DIDSBURY TECHNOLOGY PARK

INTERNAL JUNCTION LAYOUT - CHANGES

DRAWING NUMBER	REV	STATUS
159-LYR-XX-XX-DWG-L-1011	**6**	**PLANNING**

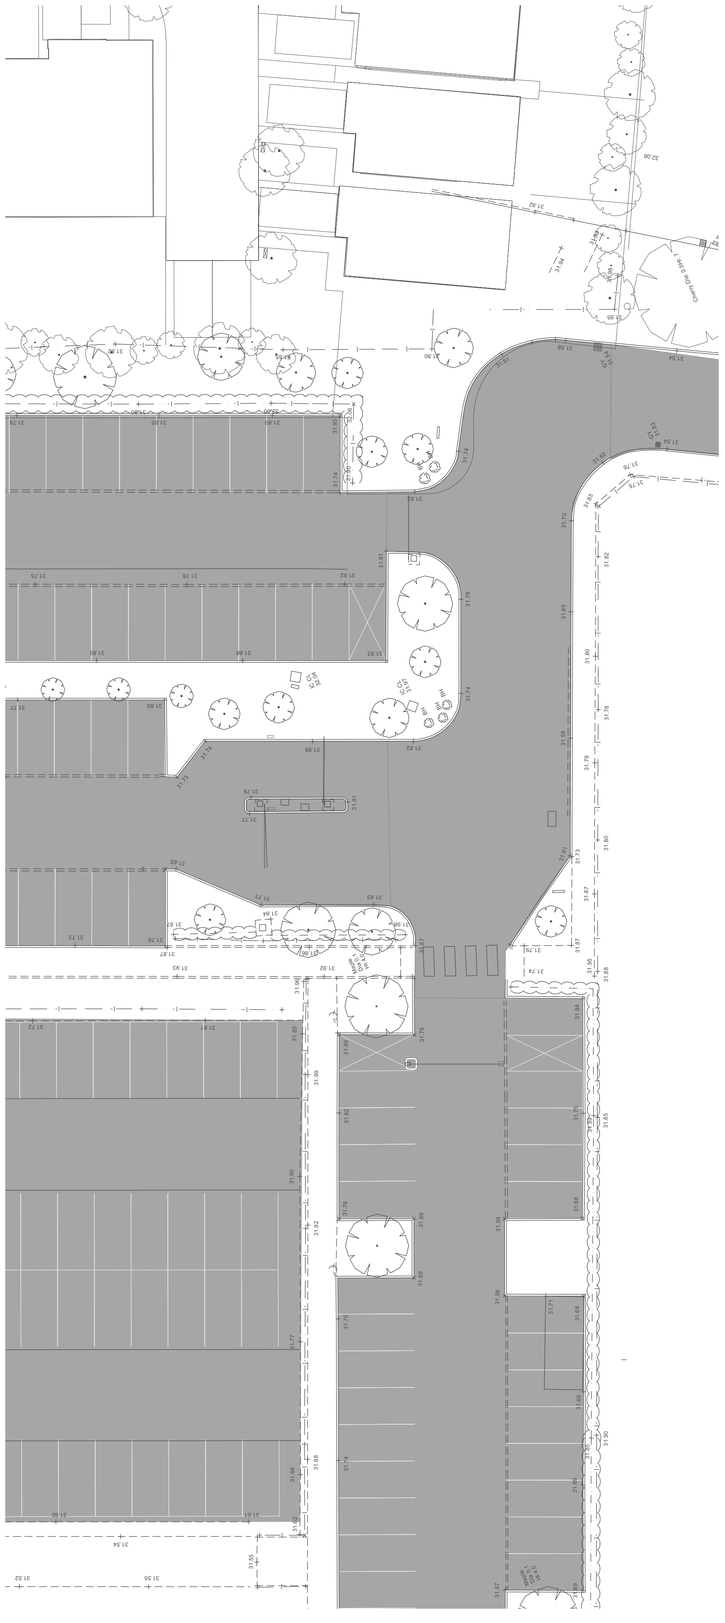
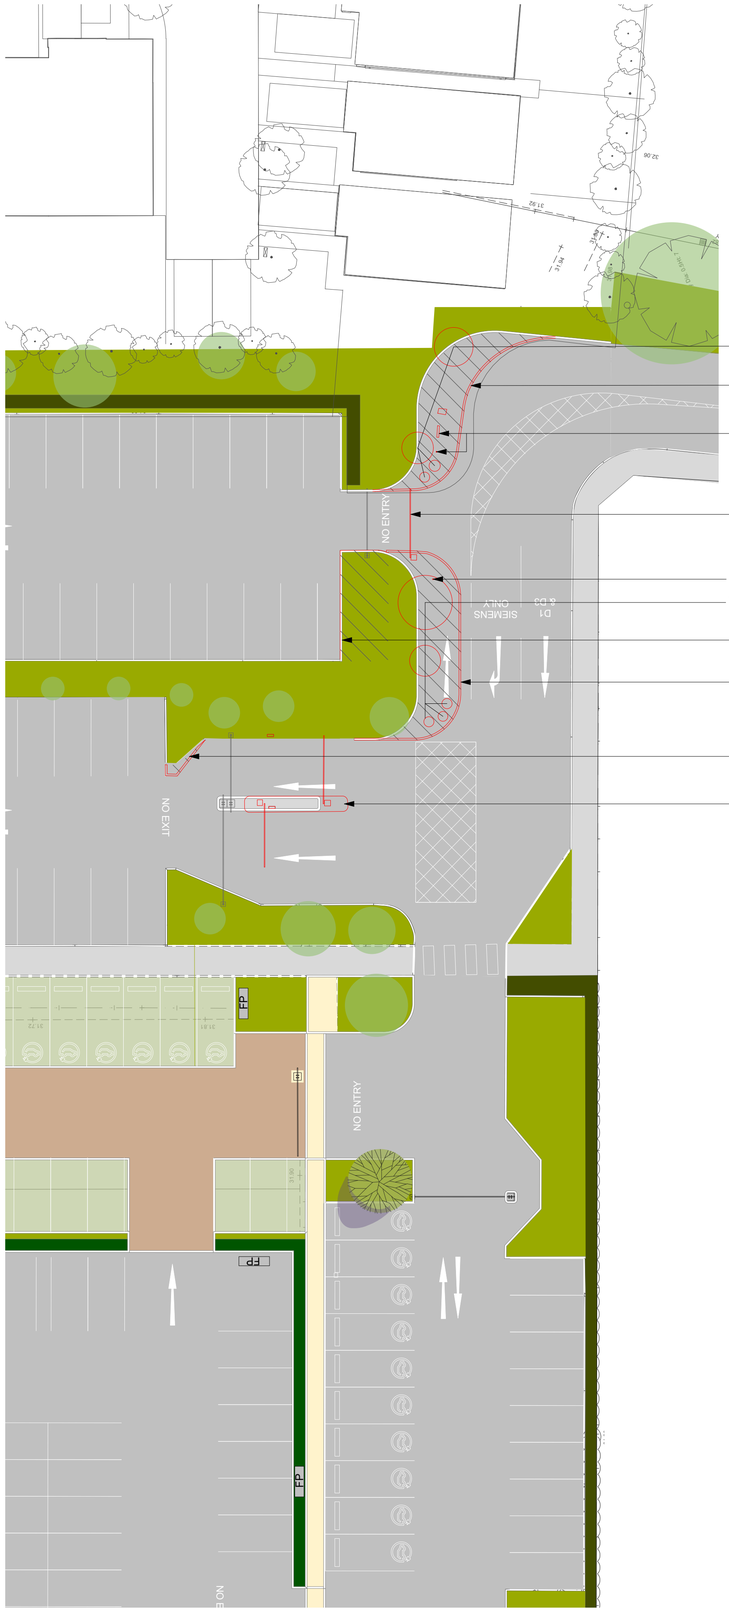
- Two trees and three shrubs removed.
- Kerbs realigned. Hatched area becomes carriageway.
- Signage repositioned.
- Barrier repositioned to align with revised kerbs.
- Signage repositioned.
- Two trees and three shrubs removed.
- Kerb line moved north to extend planting area (hatched) and mitigate loss of soft landscape.
- Kerb line moved north to create wider carriageway and separate turn right lane into Siemens car park. Hatched area becomes carriageway.
- Kerb realigned to accommodate turning circle of a large car.
- Barriers and associated infrastructure repositioned, enabling two vehicles to queue without blocking exit from D1 car park.
